PLANNING DEVELOPMENT PROPERTY

RE: Proposed S4.55(1a) Application for the Modification of Consent for SSD8440 for Amendments to the Floor Plans for Mixed Use Development (Hotel, Serviced Apartments, Residential and Carpark)

Our Ref: 17058

Figure 2 – Approved First Floor Plan and Proposed Modification to First Floor Plan

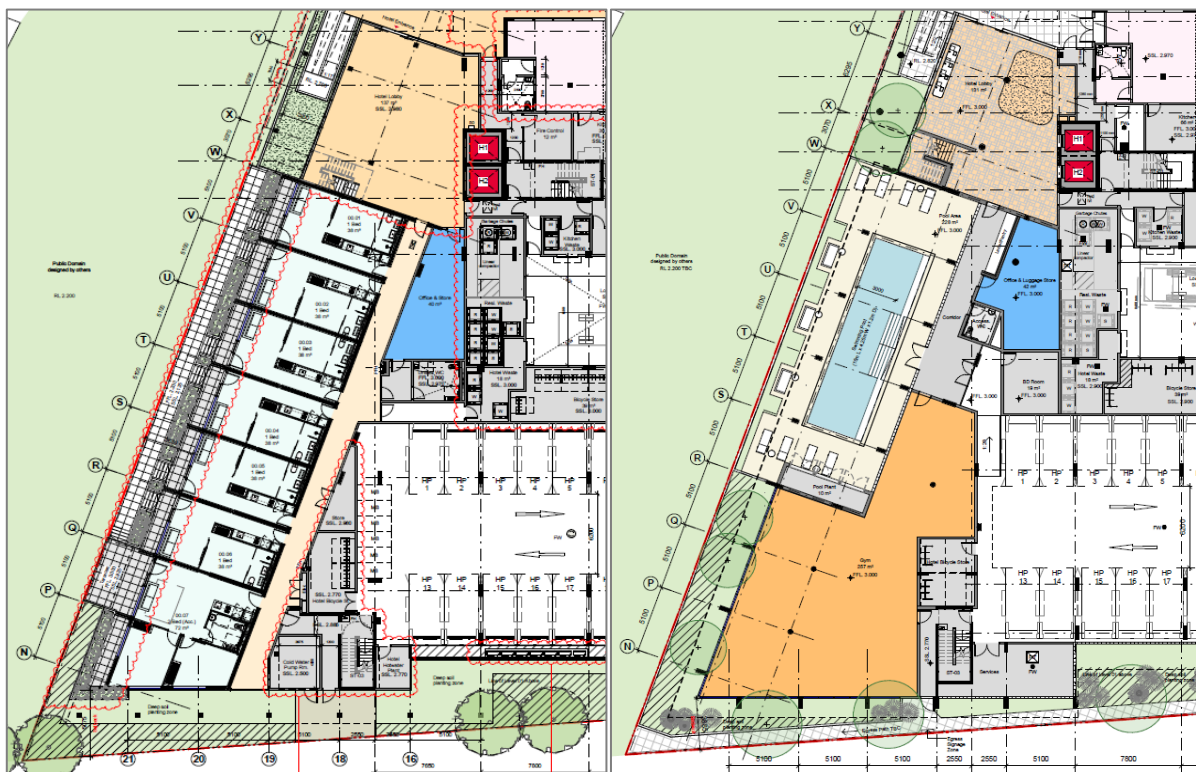
Figure 2 below shows the existing approved floor plan for the lower level. The extent of the changes include modification of the ground floor on the western side of the building. The changes predominantly relate to the removal of serviced apartments and replacement with a gym, swimming pool and service rooms. This will also include the extension of the ground floor to the south to encompass the area under the external columns to fill in the building line from the unit above.

The proposed change will result in the net decrease of 7 serviced apartments.

Figure 3 – Approved Floor Plan and Proposed Modification to Floor Plan

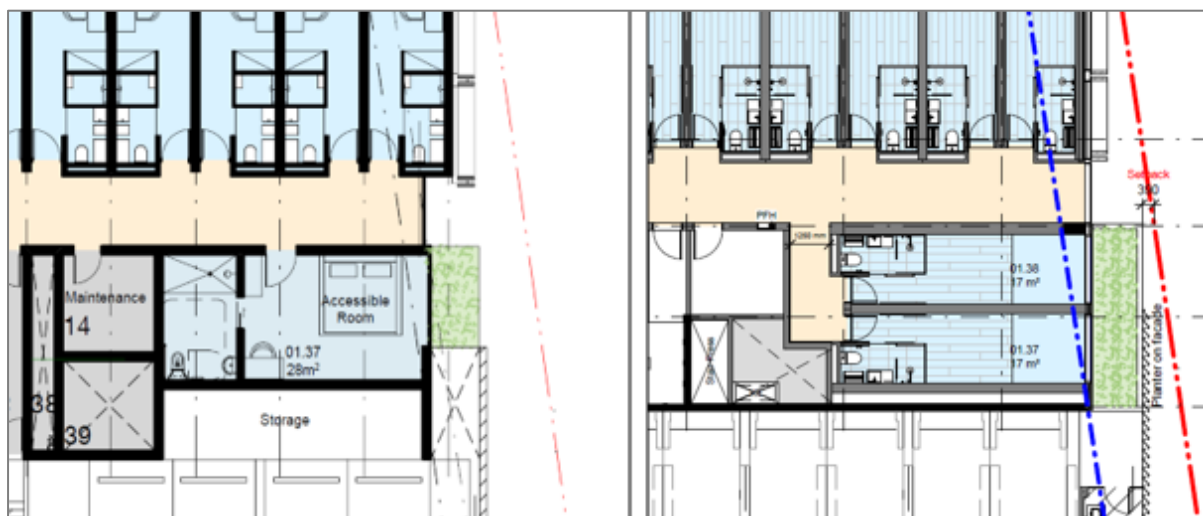
Further changes are proposed to the accessible units (1.37, 2.37, 3.37) on floors 1 to 4 on the eastern portion of the building. It is proposed that the existing single bed accessible unit be altered to contain 2 single bedroom units running on an east/west orientation. Figure 3 below show the existing floor plan on level 2, and the proposed floor plan. This format for the units will be replicated on the floors above.

The extent of the proposed changes will result in the net increase of 4 hotel rooms.

Figure 5 – Approved Western Elevation and proposed Western Elevation

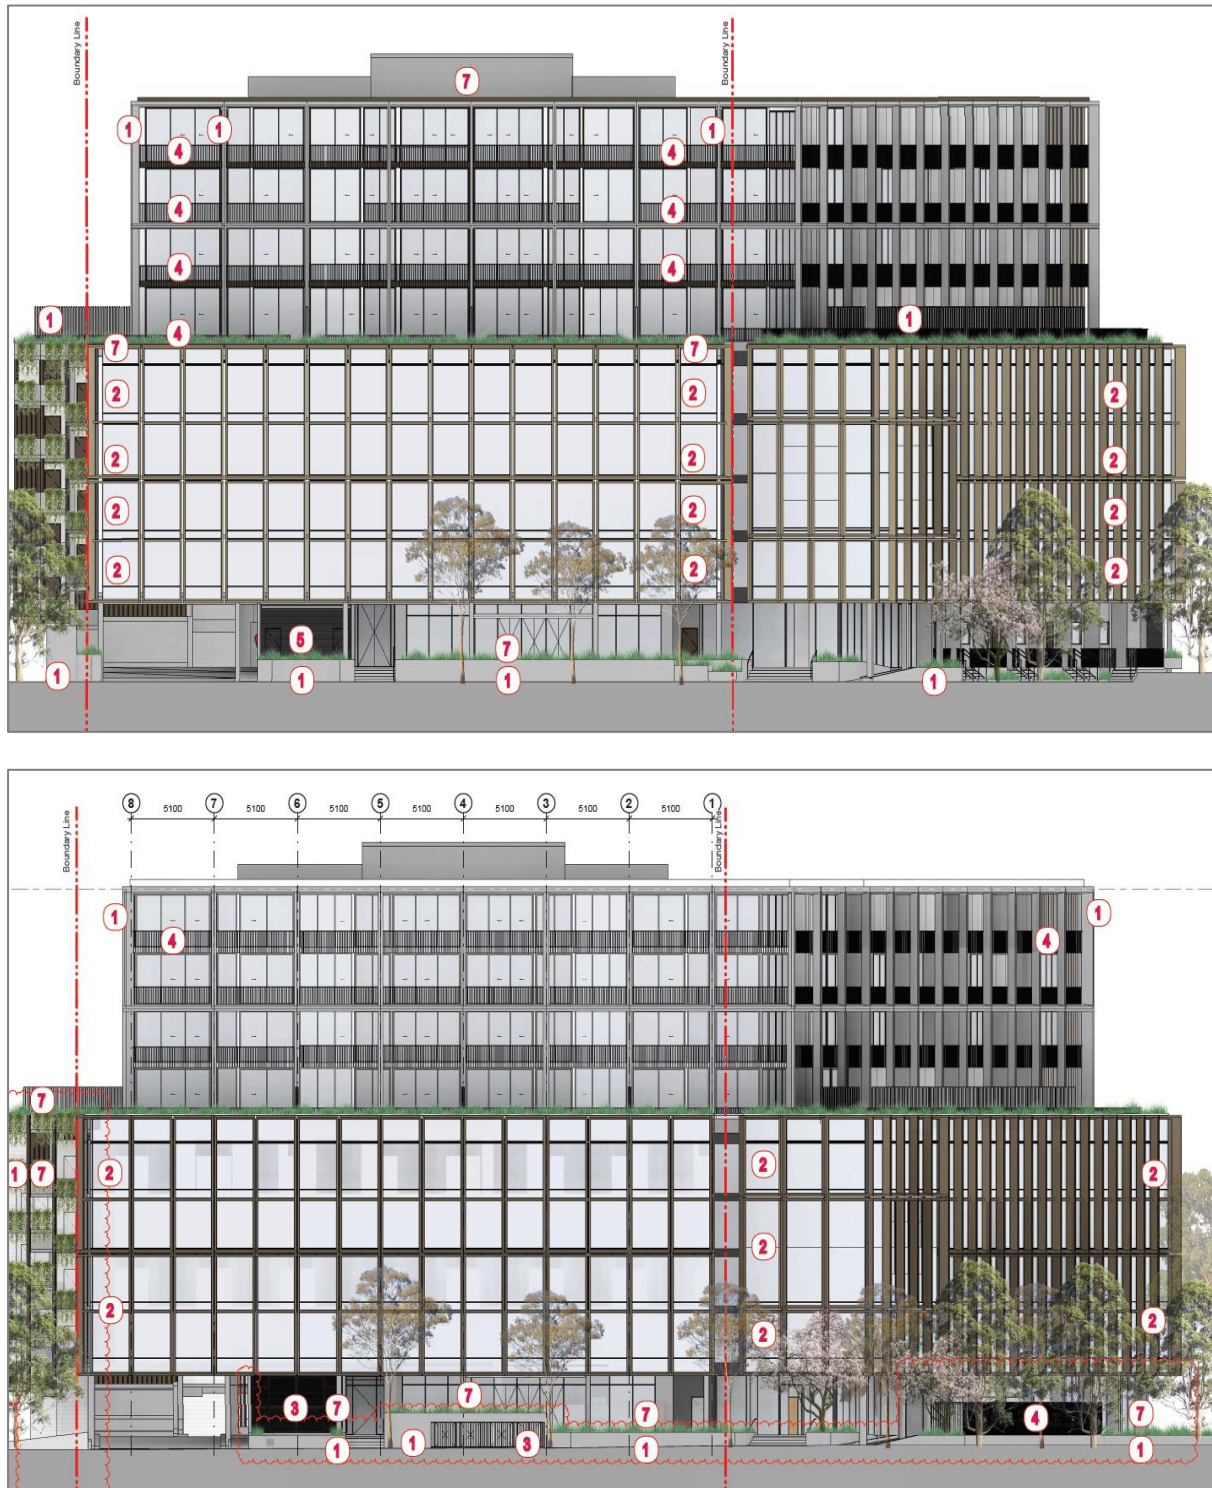
There will be no significant impacts caused on the visual impact of the building as a result of the proposed modification. The modification is wholly contained within the existing footprint of the building. The impacts that the development will have from a visual impact figures 4, 5, 6 and 7 below demonstrate the minor changes to the elevations showing the minor visual impact.
